Metropolitan Planning Commission

Staff Reports

May 26, 2011

2011SP-004-001
SMITH SPRINGS ROAD
 Map 135, Parcel(s) 146-148, 163
 Antioch - Priest Lake
 29 - Vivian Wilhoite

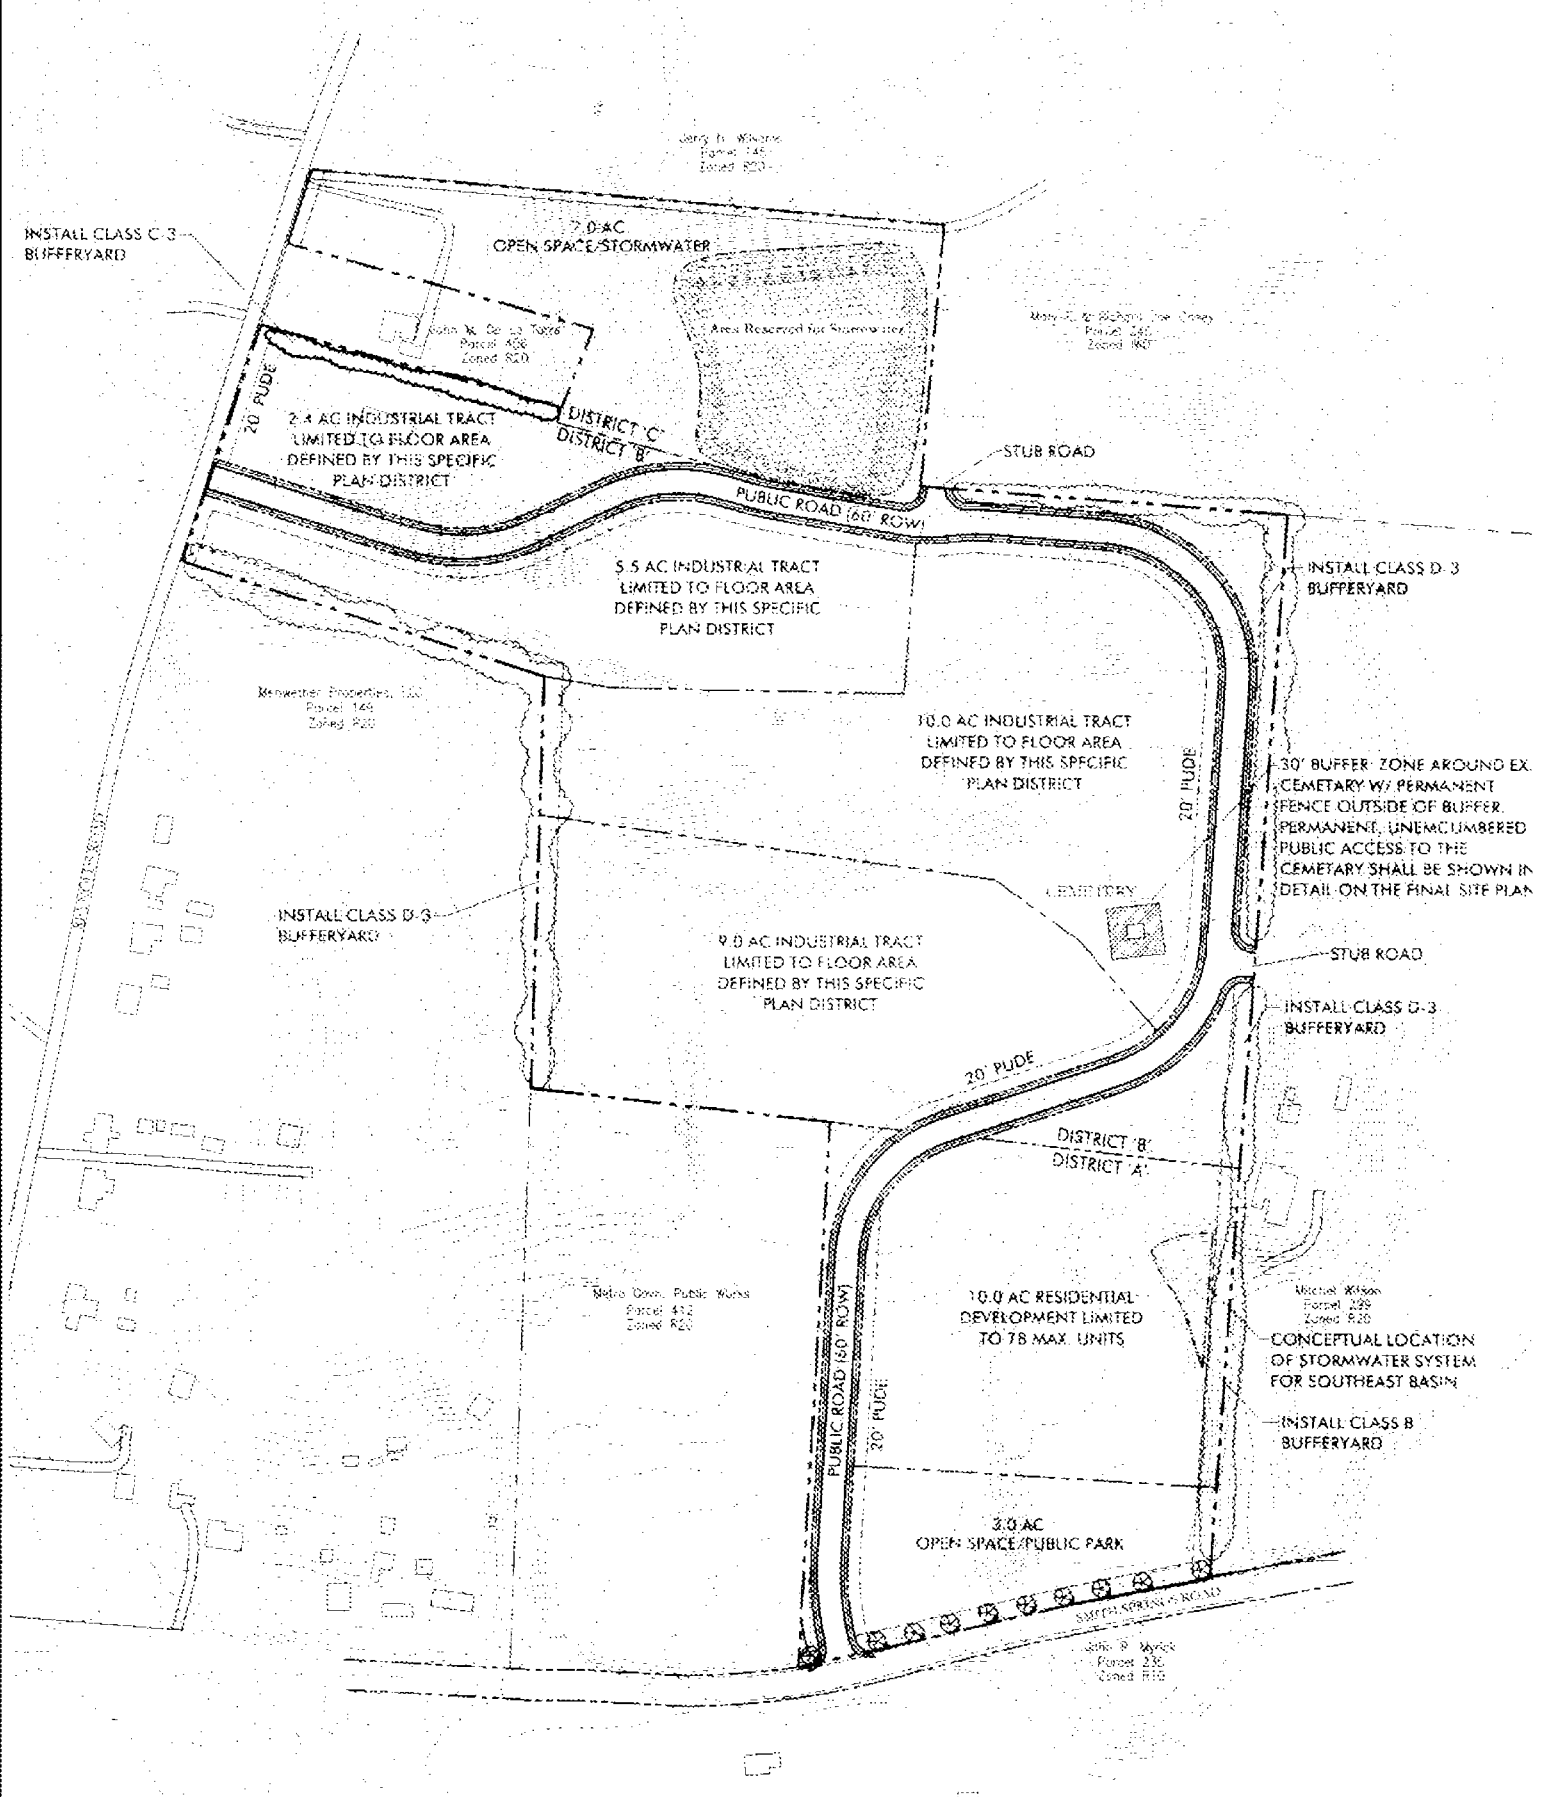
There is a cemetery located near the eastern property line. A 30 foot wide buffer with a permanent fence outside of the buffer is shown around the cemetery. A note on the plan states that permanent, unencumbered access to the cemetery shall be shown on the final site plan.

“We agree with the proposed 30’ buffer zone around the existing cemetery as well as the installation of a permanent fence outside of the buffer. The cemetery is not easily accessible at the moment, but the property owner told me that he has plans to build up the grade around it. Hopefully this will improve accessibility to the cemetery—if, by chance, descendants come searching for it. We will continue to research the history of the cemetery for our own files, and hope one day it can be properly surveyed.” (Scarlett Miles, Historical Commission)

- 1) Developer drawing should show any existing utilities easements on property and the utility poles on the property and/or r-o-w.
- 2) 20 foot public utility easement required adjacent to all public r-o-w.
- 3) NES can meet with developer/engineer upon request to determine electrical service options
- 4) NES needs any drawings that will cover any road improvements to Metro r-o-w that Public Works will require.
- 5) NES follows the National Fire Protection Association rules; Refer to NFPA 70 article 450-27; and NESC Section 15 - 152.A.2 for complete rules (see NES Construction Guidelines under “Builders and Contractors” tab @ www.nespower.com).
- 6) NES needs to know if the developer has other options on property next to this area, if so NES needs an overall concept plan.
- 7) 20 foot public utility easement shall be clear of any permanent footings and structures.

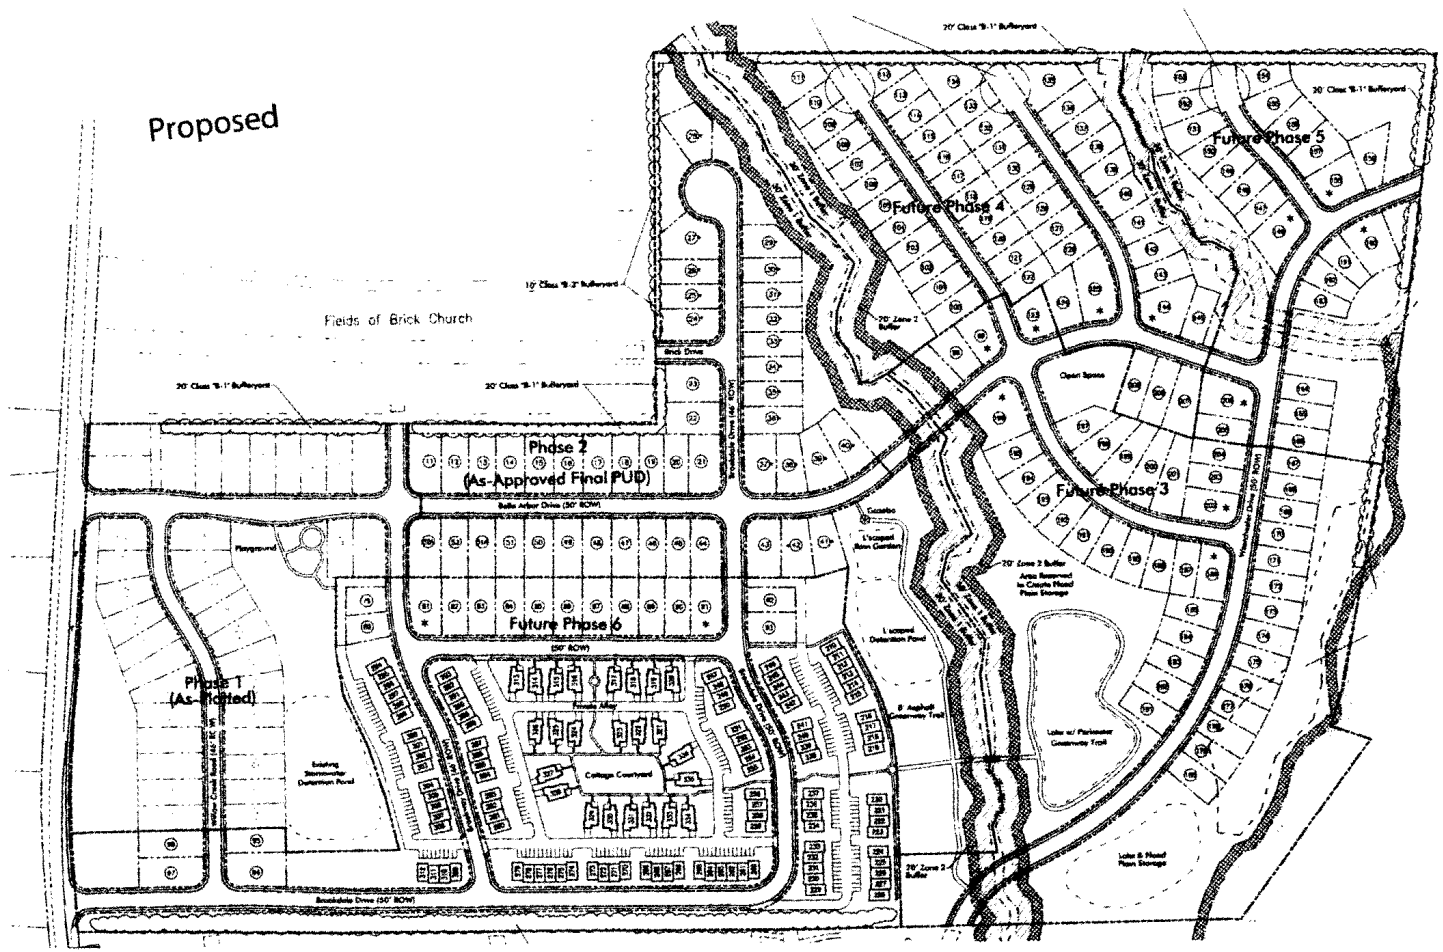
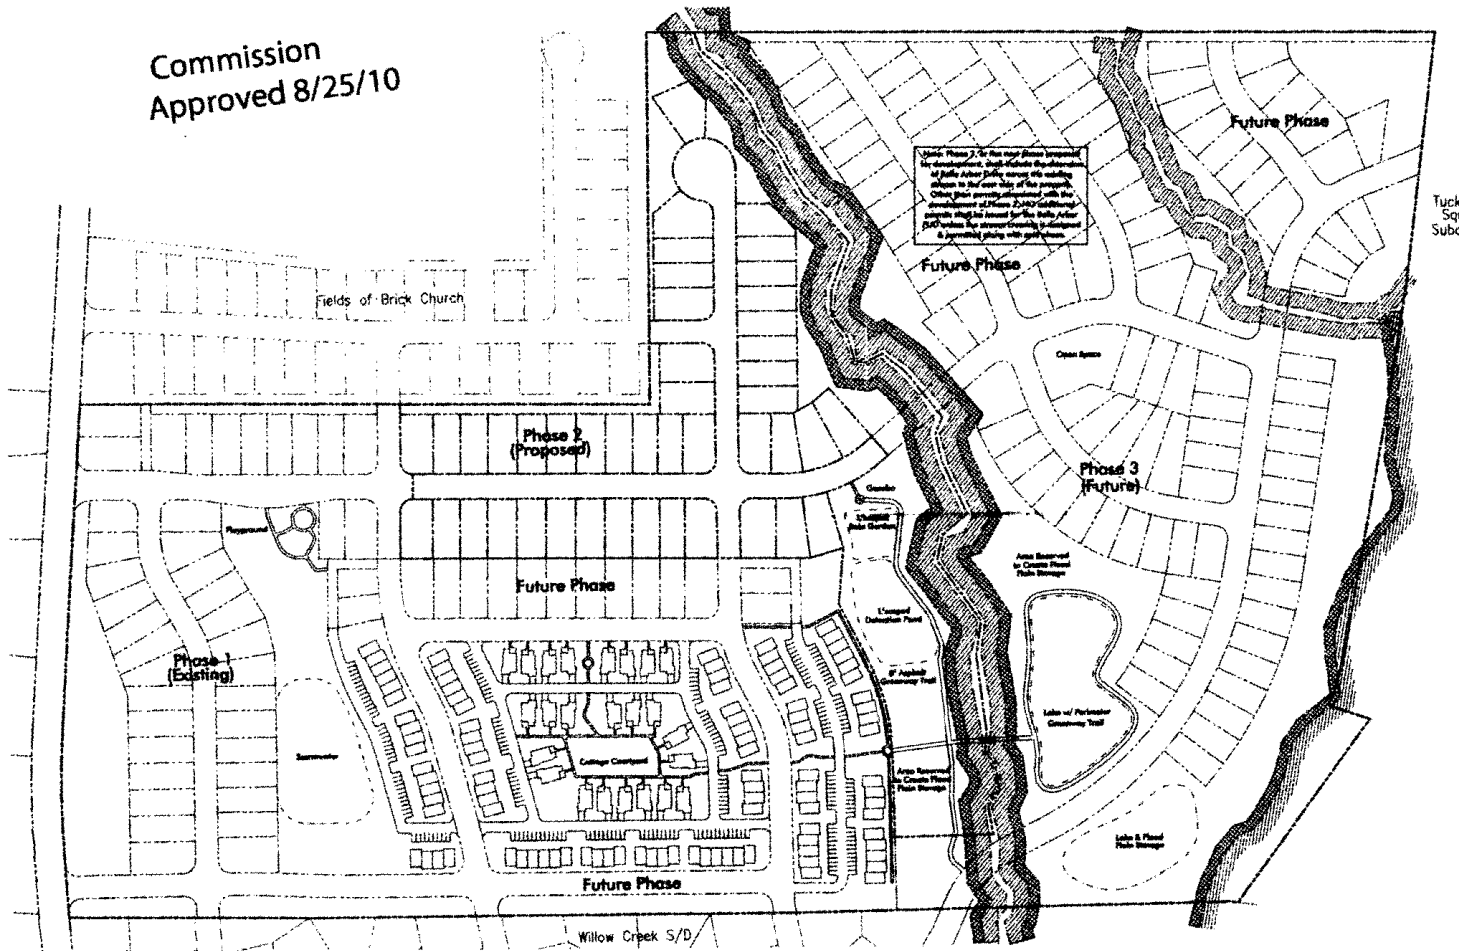
As proposed, three local street connections to the south will be eliminated. All three connections would connect to existing streets in the adjacent Willow Creek Subdivision – Willow Creek Road, Brookway Drive and Brookdale Drive. One street connection to the Willow Creek Subdivision, Westchester Drive, will remain, and will eventually connect to a northern section of Westchester Drive in the Tuckahoe Subdivision to the northeast. Additional street connections are provided to Brick Church Pike and Brick Drive. Three stub-streets provide for future connections to undeveloped land to the north.

Staff is recommending disapproval of the request for several reasons. The elimination of the three street connections is not consistent with the overall intent of the PUD ordinance. According to the Metro Zoning Code (Section 17.36.030), the intent of a Planned Unit Development Overlay is to provide an “alternative zoning process that allows for the development of land in a well-planned and coordinated manner”. It permits a “greater mixing of land uses”, and “a framework for coordinating the development of land with the provisions of an adequate roadway system”. Minimum performance standards for a Planned Unit Development include “Coordinated

The request is not consistent with the approved long-range transportation plan for the Parkwood/Union Hill community plan. The long-range transportation plan calls for at least two connections within the area connections are proposed to be eliminated.

The plan is not consistent with the adjacent Willow Creek Subdivision that was approved by the Planning Commission in 1983. The subdivision provides for the connections now proposed to be eliminated. Removal is in contradiction to the concept that was originally approved by the Commission, which provided for sufficient connectivity. With the removal of the connections Willow Creek Road, Brookway Drive and Brookdale Drive become permanent dead-end streets without a turn-around. Each street is well over 150 linear feet, and current regulations including the Subdivision Regulations and the fire code prohibit dead-end streets over 150 feet without a turn-around. Due to the fact that the streets will be over 150 feet, and will not have a turn-around, the Fire Marshal’s Office is recommending disapproval.

While the plan does not eliminate all street connections to the south, a majority of the southern connections, which would connect to existing streets, will be lost. Westchester Drive, the remaining southern connection will eventually link Brick Church Pike to Bellshire Drive and Dickerson Pike. Because Westchester will provide a more direct connection between major streets, and will also provide access to numerous homes, then it should be expected to have more trips than Willow Creek Road, Brookway Drive and Brookdale Drive. The three connections now proposed to be removed will provide for more options for local traffic and provide for safer connections for pedestrians and bicycles.

In conclusion, staff recommends disapproval of the proposal to eliminate the three street connections. The elimination of the connections is not consistent with the PUD Overlay requirements, the Parkwood/Union Hill community plan, or the concept for the adjacent Willowcreek Subdivision. Removing the street connections is also not consistent with overall planning goals, which among other goals, is to provide for a well-

Staff recommends disapproval. The removal of the three street connections is not consistent with the PUD Overlay requirements, the Parkwood/Union Hill community plan,

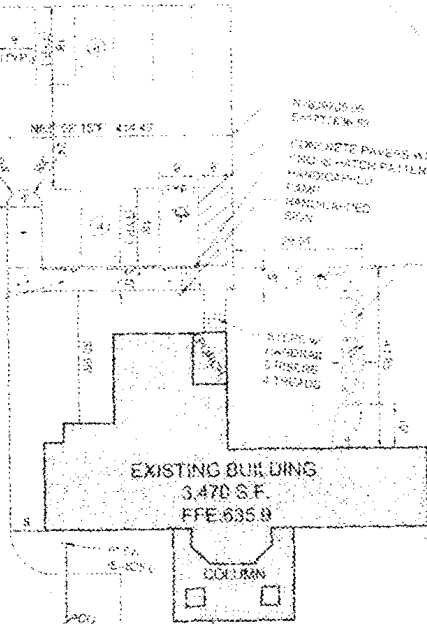
Only stopping sight distance is documented on plan. Provide and identify intersection sight distance. Show sight distance triangle and measurements.
